ERRATA SHEET BOG CREEK ROAD PROJECT FINAL ENVIRONMENTAL IMPACT STATEMENT______

Table Errata-1. FEIS Revisions made in response to Letter 108 comments and newly available information, not previously addressed through the February 15, 2019, version of the FEIS

Bog Creek Road Project

Figure 2.2.2. Current (2017) motorized use and current drivability conditions.

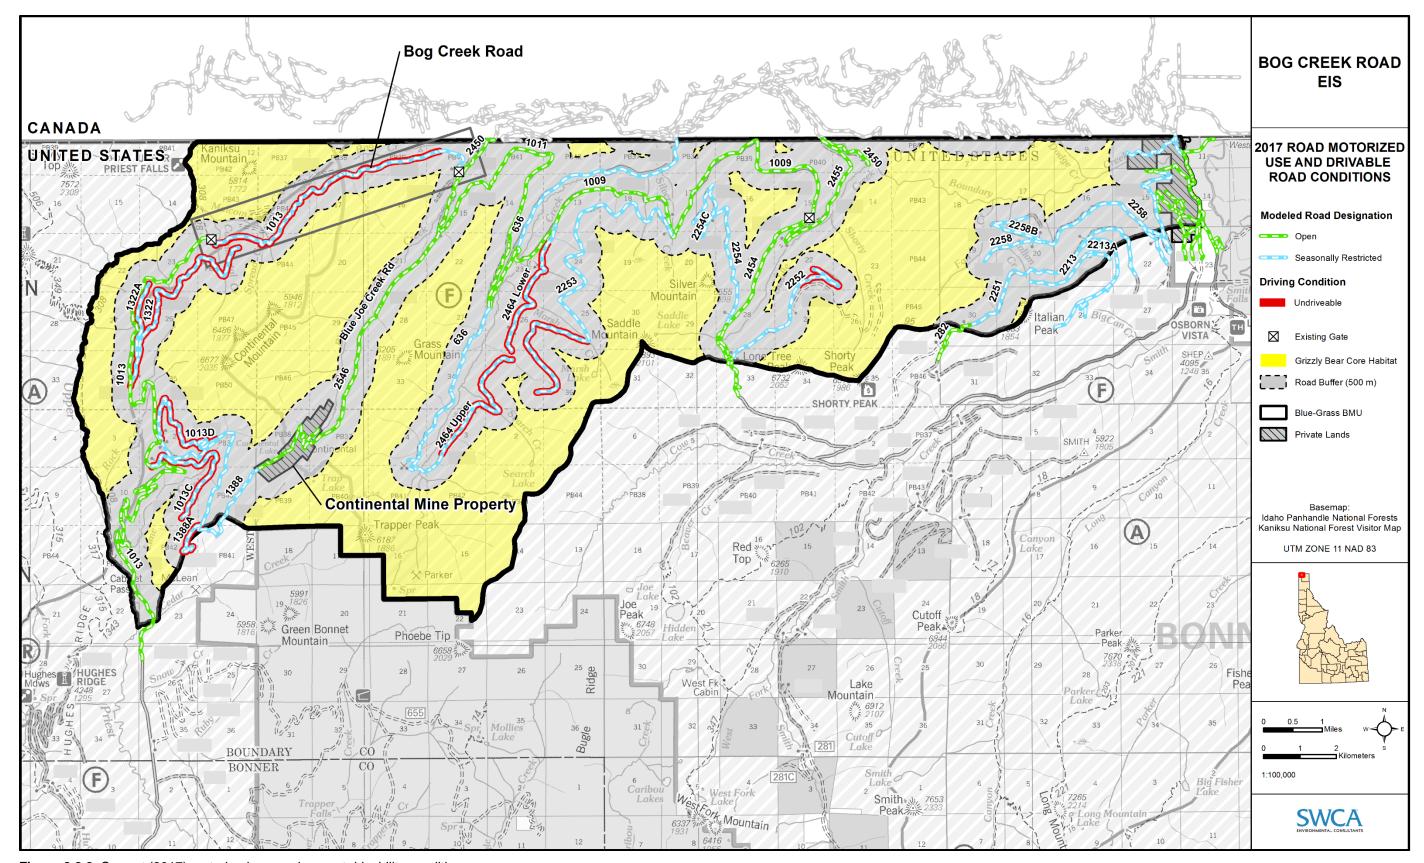
Chapter 2 – No Action Alternative	Through Biological Assessment (BA) review, the agencies identified inaccuracies regarding drivability of FSRs 2252 and 2253. BA Figure 3.2 and FEIS Figure 2.2.2 have been revised to reflect current road drivability conditions (these changes did not affect FEIS tables or analyses):	
		 FSR 2253 drivable for the first 5.5 miles (to Marsh Creek), and FSR 2252 undrivable for only the last 1.3 miles.
